PROJECT PROPOSAL

- 5 Story Multifamily Building
- 51 Dwelling Units
- 0 SF Commercial Area
- 0 Live Work Units
- 0 Parking Stalls
- 54 Bicycle Parking

MASSING & FACADE ARTICULATION

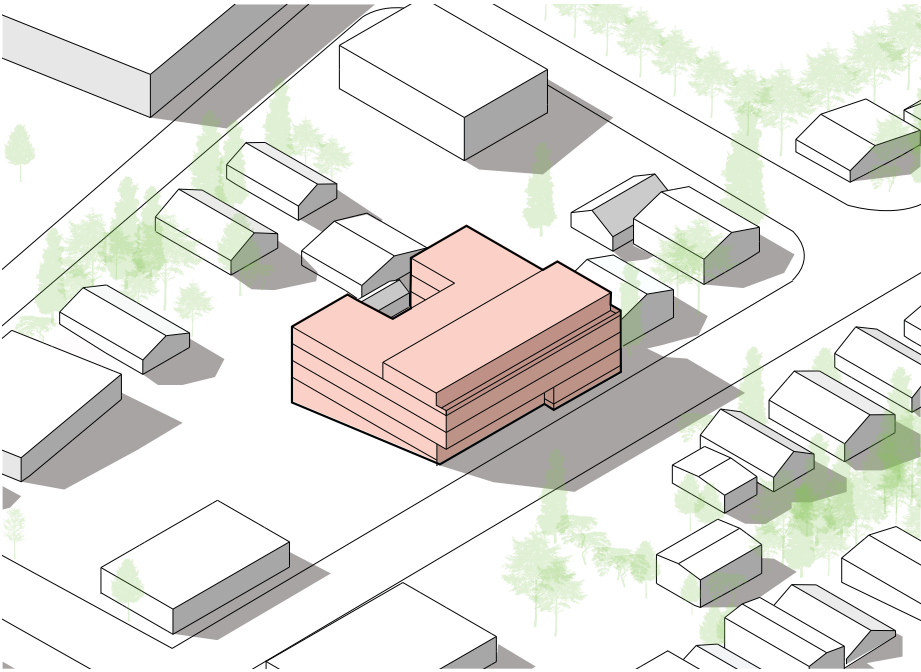
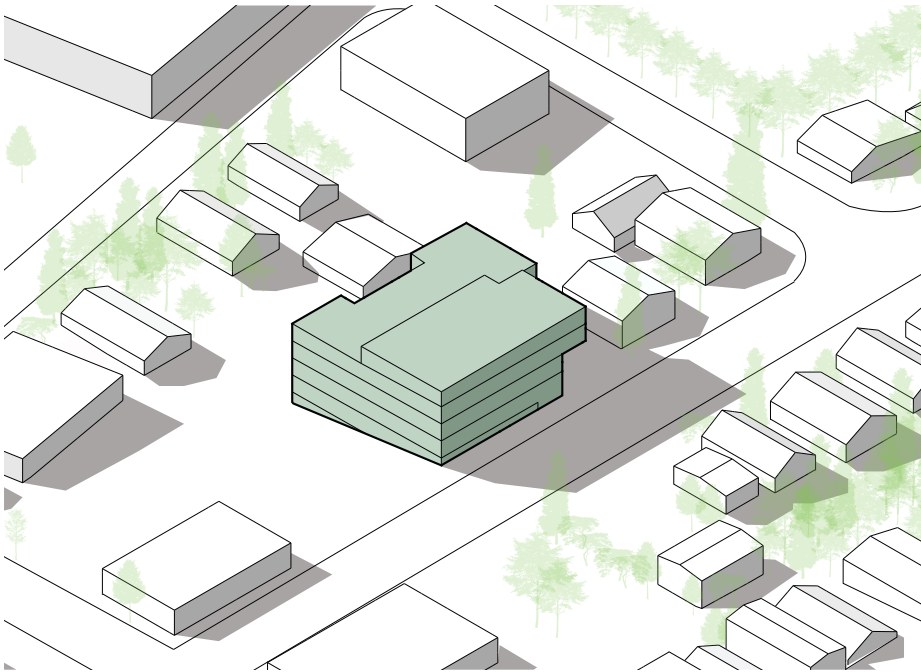
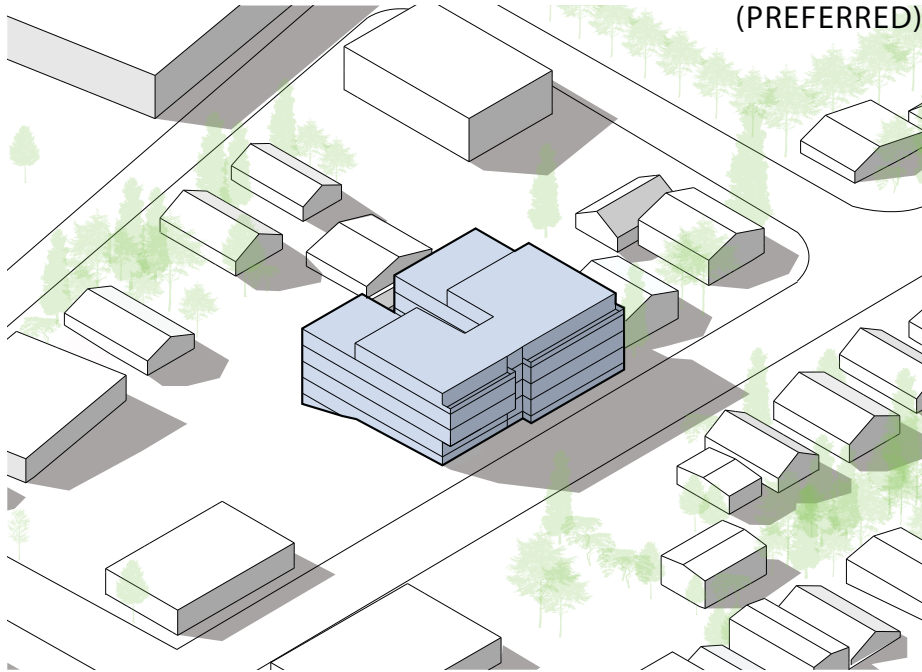
The board supported the modulation, regarding the zone transition, and the well-proportioned facade along 37th Ave S in option 3. They also found the massing of option 1 to be successful with the layout of the interior spaces and the courtyard. The board recommended the massing treatment of the east facade in option 3 to be expressed on other facades. They also recommended the upper level of the structure to be setback on the north and south facades to break up the perceived massing. The board requested further articulation for the north and south facades.

The board recommended the use of secondary architectural elements for all facades to strengthen the design of the proposal and break up the perception of mass.

In response to the board’s discussion the project has incorporated the massing and internal layout of option 1 while maintaining the facade modulation of option 3. The massing treatments present at the east facade have been addressed and expressed on the remaining facades. To incorporate the massing of option 1, the building’s east/west depth has been reduced by eight feet. This in turn has reduced the units at the east side of the courtyard to sixteen feet. The reduction of the structure depth has the added benefit of providing greater at grade amenity space and better opportunities for daylighting and views. New articulation at upper level setbacks and facade modulation to both the north and south facades offer logical locations for material transitions, provide well-proportioned facades, and have lessened the perceived mass of the structure. Additionally, decorative panel guardrails are proposed at all facades to mimic the decks at the east facade. These provide secondary architectural elements which reduce perceived mass and provide architectural inter-

In response to the board’s discussion secondary architectural elements have been incorporated into all elevations via decorative panel guardrails. The decorative panel guardrails mimic the treatment at the 37th Ave S facade to warrant equal facade treatment while clearly delineating between the street facade and internal site facades. The north and south facades include modulation via a small recess, materials changes, and upper floor setbacks. This reduces perceived massing to the less developed adjacent parcels. Exterior courtyards, roof decks, main building entry, and individual unit stoops along 37th Ave S have been further developed to include architectural features, elements, and details. Planting beds have been incorporated at the building main entry to provide a physical separation between the private, at grade entries and the solid waste enclosure while providing opportunities for exterior seating. The individual unit stoops incorporate metal grated guardrails which, over time, will incorporate vertical landscaping, provide privacy for the tenants, and provoke interest for pedestrians. Roof decks and courtyards include ample landscaping, thus providing privacy to adjacent units and softening hardscape surfaces.

FLOOR PLANS | Level B1 & Main

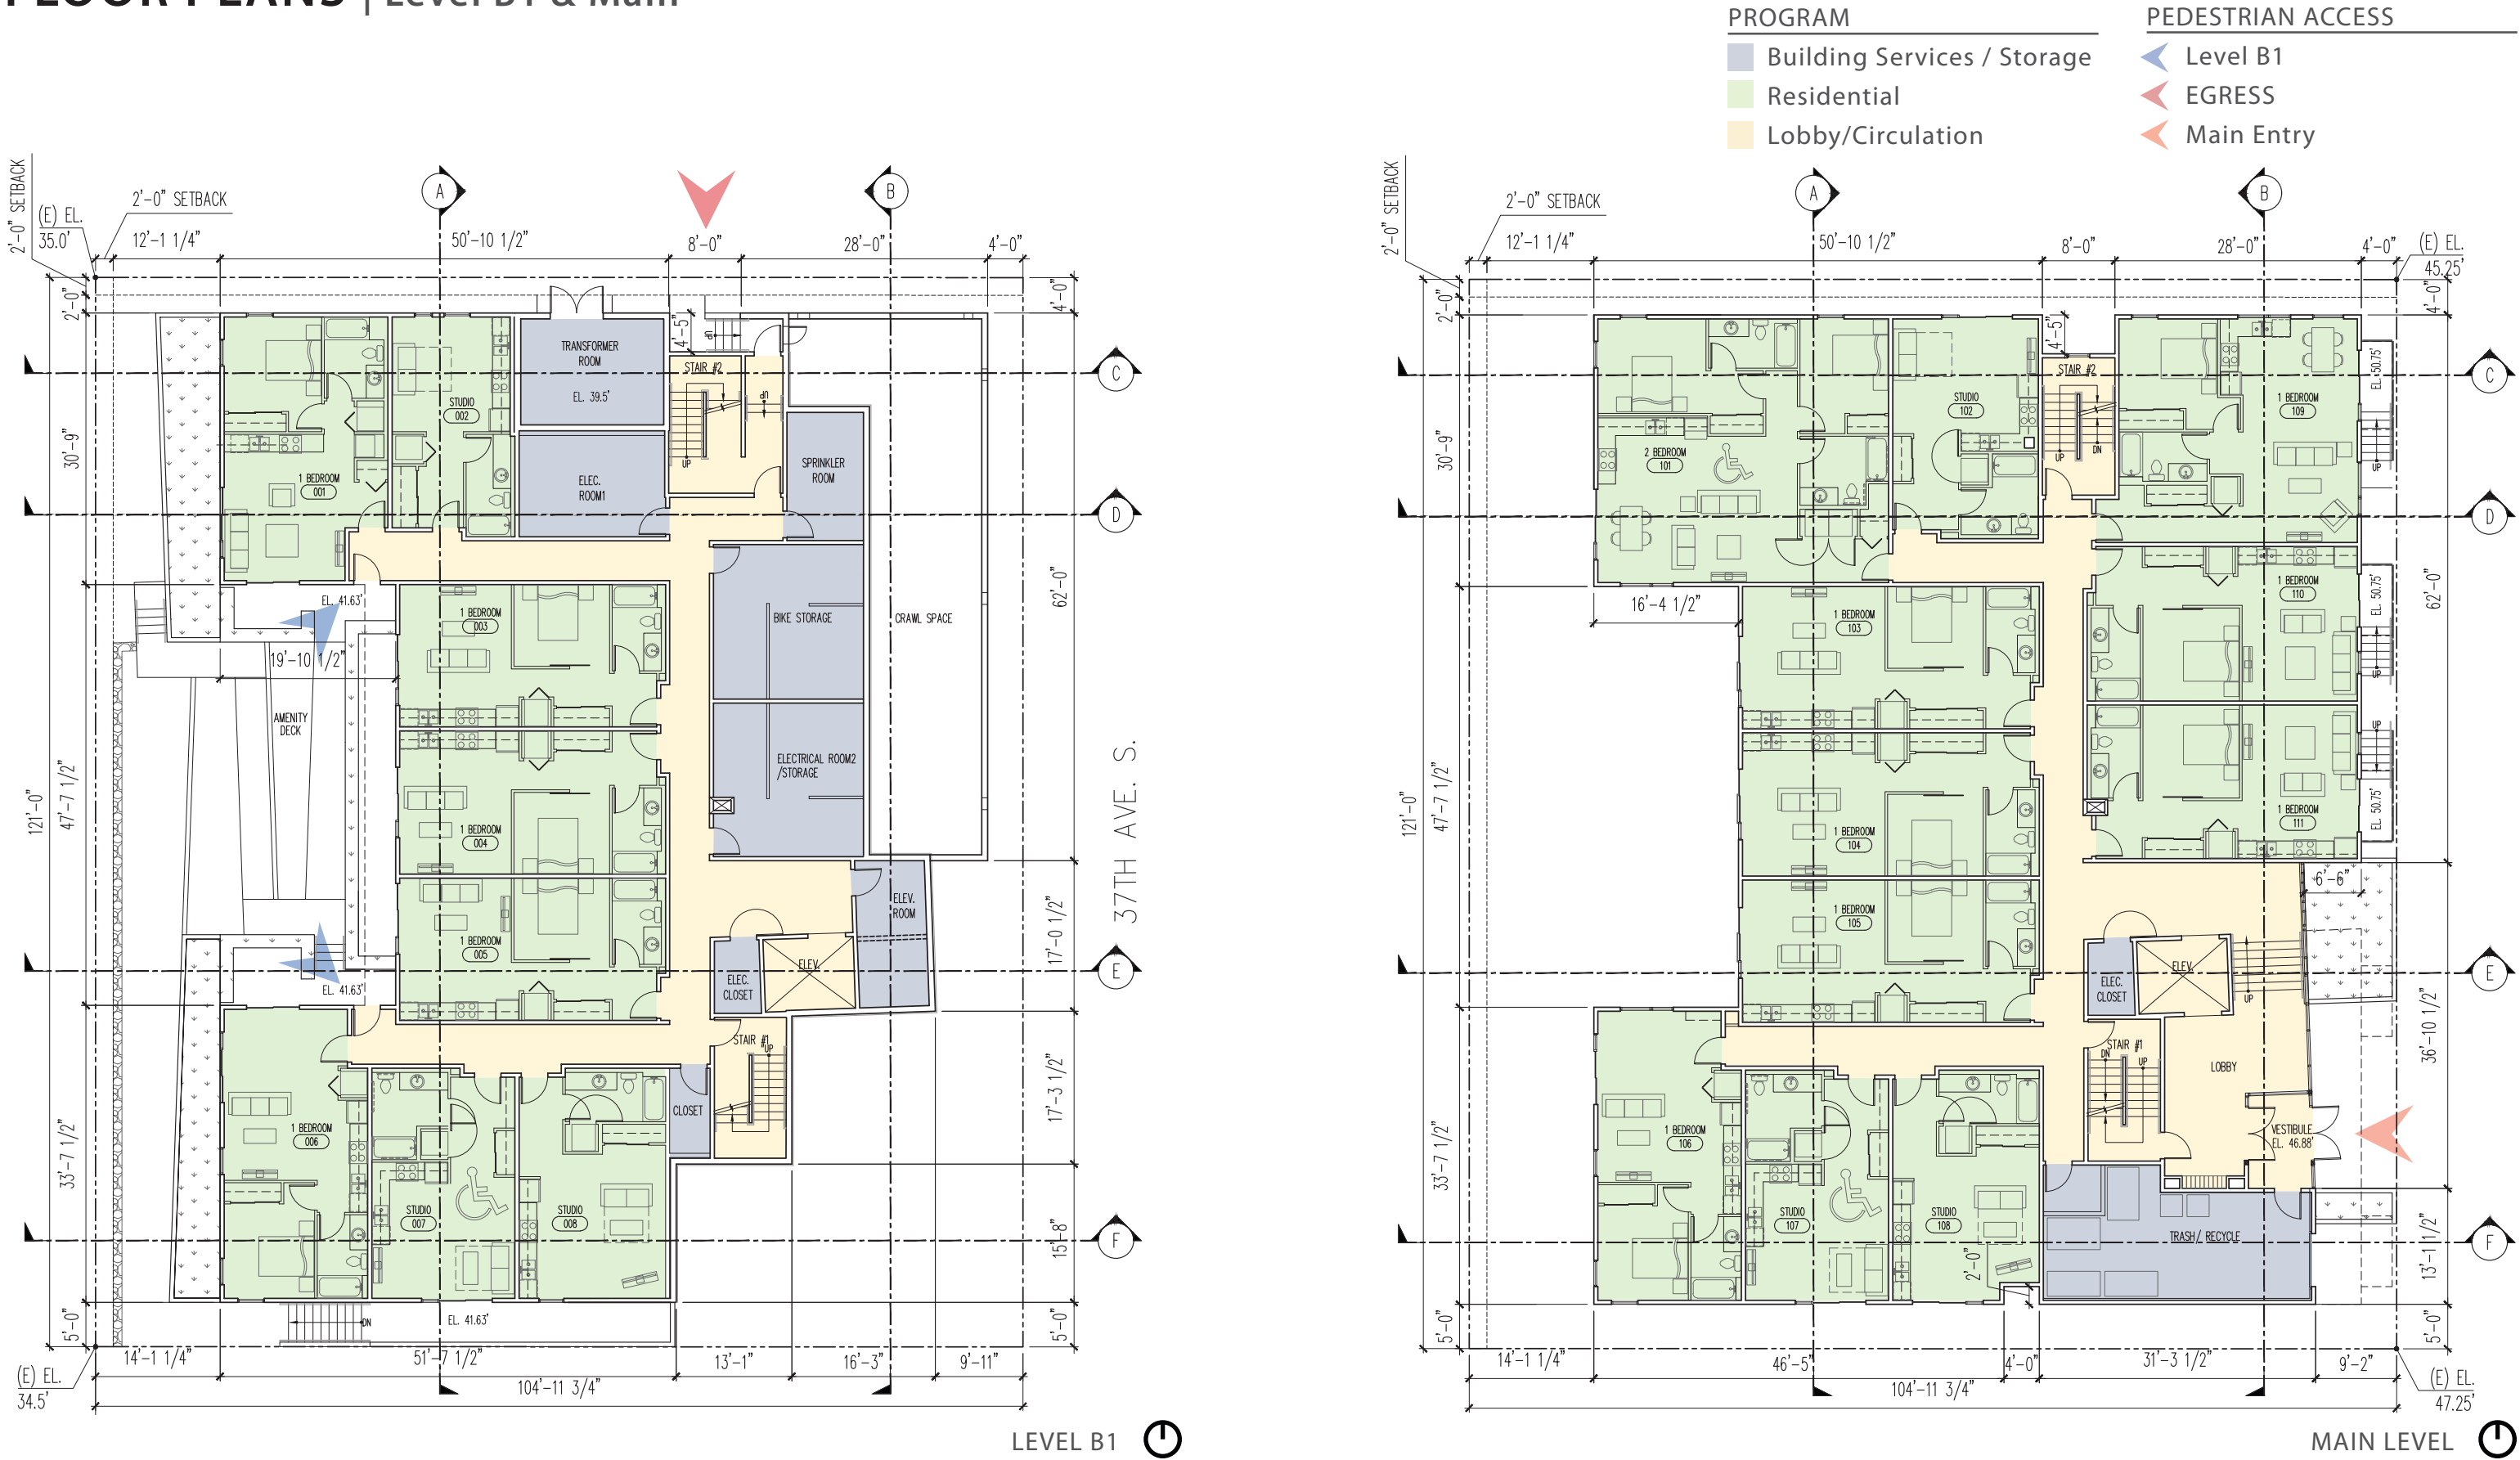
The board recommended further refinement of the layout of the interior spaces proposed in option 1 with consideration of livability, courtyard access, circulation, unit size, and daylighting. The Board requested exploration of design regarding the courtyard to accommodate ADA accessibility and response to the topography. The board preferred the layout of the larger roof amenity area in option 1 that faces the alley.

The board supported the recessed primary entry, which helps to distinguish it from the entries of the at grade residential units. The board recommended emphasizing the connectivity of these units to the public realm of 37th Ave S. The board also recommended that these units have more residential character in the design of the individual entries, pulling from the context of the neighborhood and further differentiating them from the primary entry.

In response to the board’s discussion the internal layout of option 1 has been incorporated reducing the depth of the recess to improve the arrangement of interior uses and daylighting to those units adjacent to the courtyard. The courtyard has been revised to a series of ramps. In addition to providing accessible access to the courtyard and rear yard, the ramp system creates an active environment with opportunities for seating and privacy nodes. The upper roof deck amenity is maintained but has been relocated to the west side of the roof to eliminate privacy concerns for the residential structures in the LR3 zone across the street.

In response to the board’s discussion the primary building entry remains recessed and is further distinguished from at grade residential entries with extensive glazing, raised exterior concrete planters, and concrete paving. The at grade residential entries are further differentiated from the primary entry via landscaping, materials, and elevation. As required by code the residential entries are elevated four feet above grade providing tenant privacy and separation from pedestrians and the adjacent ROW. Materials utilized include brick veneer and galvanized bar grating guardrails which, over time, will include vertical landscaping and a residential appearance. Ample landscaping is provided adjacent to the residential entries with reduced height to improve visibility and potential for interaction.

COMPOSITE LANDSCAPE PLAN | Landscape Plan

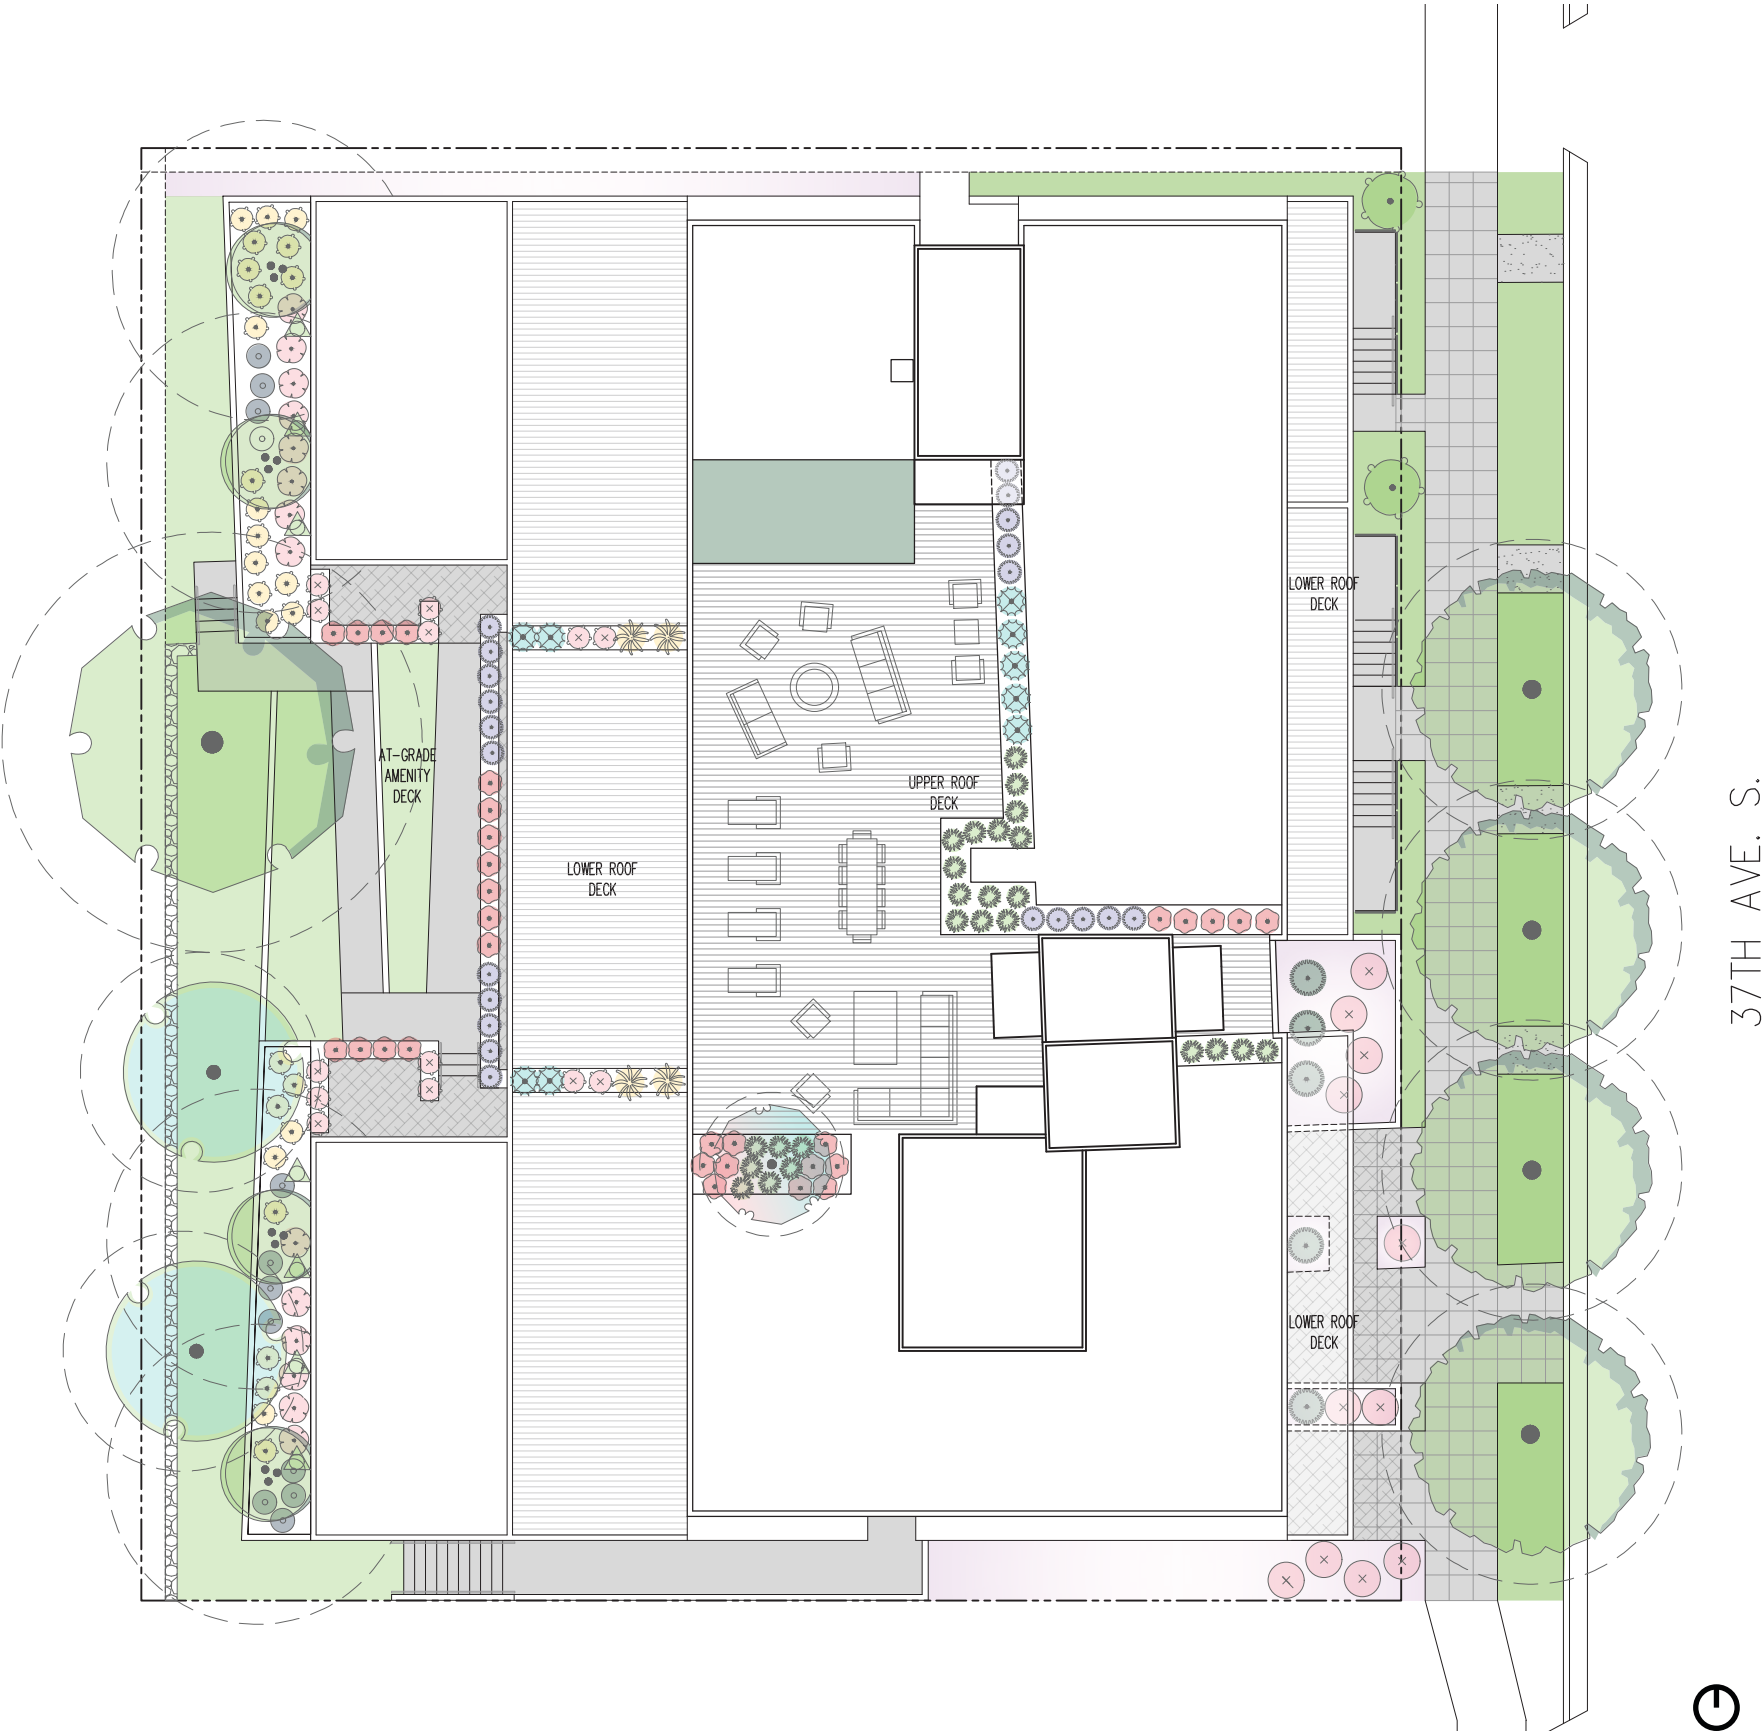
The board recommended developing landscaping that was conducive to pedestrian interaction with the use of various landscaping elements to give more residential character to the at grade units along 37th Ave S. The board supported landscaping along the back alley to create a public space that connects to the courtyard amenity area. The board also expressed their support for an exemption from making improvements to this back alley.

In response to the board’s discussion landscaping adjacent to the at grade residential units has been reduced in height to lessen the buffer between the public and private realms and to be more conducive to pedestrian interaction. Bar-grating guardrails have been incorporated to allow for vertical landscaping at these unit entries to provide a sense of privacy for tenants, while maintaining a residential expression. The alley is no longer required to be improved as parking has been eliminated. The courtyard includes a series of ramps providing access to the rear yard and unimproved ROW. While the ROW is accessible to tenants and will likely be maintained and used as an extension of the at grade amenity, it is not subject to landscaping improvements.
